# ARDENWALD NORTH IMPROVEMENTS

Tabling Event – June 22, 2022

### Questions and comments from the Tabling Event:

### Modifed from OSD Curbs RD 700

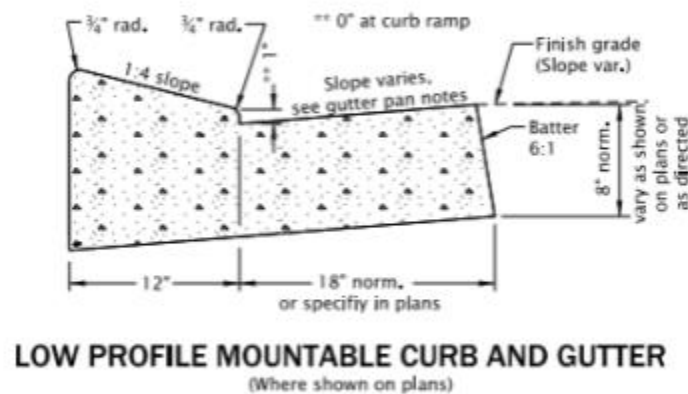
Q: In the discussion, a modified low profile mountable curb and gutter are planned for Roswell Street and Van Water Street. How high is this curb?

A: The exact curb detail is shown on the Oregon Standard Drawings RD700. The detail shows a 12" wide curb with a gutter dimensioned as "18" norm. or specify in plans". For this project, the gutter will be 12" wide. The total curb width will be 24". The curb slope is listed as 1:4 slope, a 12" wide curb will be 3" high.

Modified in plans to specify 12" gutter
